**HIROSE ELECTRIC CO., LTD.**  
2-6-3 Nakagawa Chuoh, Tsuzuki-ku, Yokohama, JAPAN

### Product Change Notification

■ Product List PCN2020-12\_DF12 series material change and packing specification change

■Details of changes DF12 series material change and packing specification change

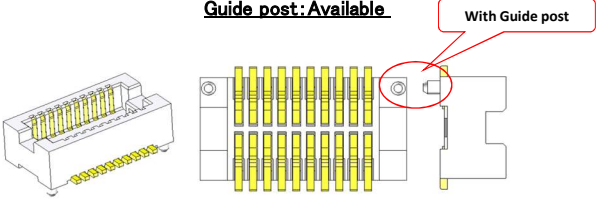
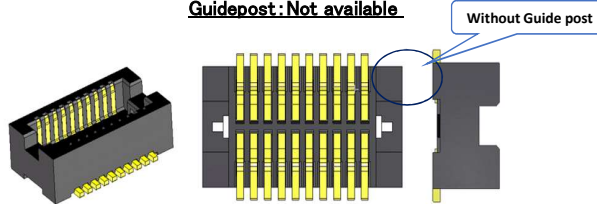
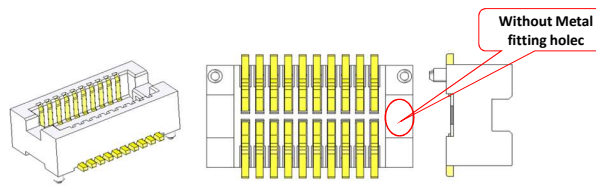
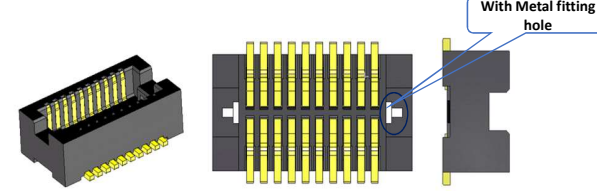
<p style="text-align: center;"><b>Before</b></p> <p style="text-align: center;"><b><u>Resin material: PA46</u></b></p> <p>Resin material: Polyamide (PA46, 46 Nylon) Resin Material Color: Beige MSL: PA46 is equivalent to MSL 2a Product appearance</p> 	<p style="text-align: center;"><b>After</b></p> <p style="text-align: center;"><b><u>Resin material: PA9T</u></b></p> <p>Resin material: Polyamide (PA9T, 9T nylon) Resin Material Color: Black MSL: PA9T is equivalent to MSL 1 Product appearance</p> 
<p style="text-align: center;"><b><u>Guide post: Available</u></b></p> 	<p style="text-align: center;"><b><u>Guidepost: Not available</u></b></p> 
<p style="text-align: center;"><b><u>Without Metal fitting hole</u></b></p> <p>Housing mold of no metal fitting type is flat and has no holes.</p> 	<p style="text-align: center;"><b><u>With Metal fitting hole</u></b></p> <p>Housing mold has holes even for no metal fitting type.</p>

<p style="text-align: center;"><b><u>Packing state: Deaerated in aluminum bag</u></b></p>  <p>The reel is put in an aluminum bag and</p> <p>Attach a product name label to identify the contents</p> <p>With dry material (silica gel)</p>  <p>Product name label</p> <p>Humidity indicator</p> <p>The MSL of the product is equivalent to 2a, and since it may absorb moisture during storage. It is packed with a special specification for the purpose of improving moisture resistance.</p>	<p style="text-align: center;"><b><u>Packing state: No bag packing</u></b></p>  <p>Reel is packed in a box without bag</p>  <p>Product name label</p> <p>The MSL of the product is equivalent to 1, and the risk due to moisture absorption during storage is eliminated. Packaging specification is returned to normal packaging.</p>
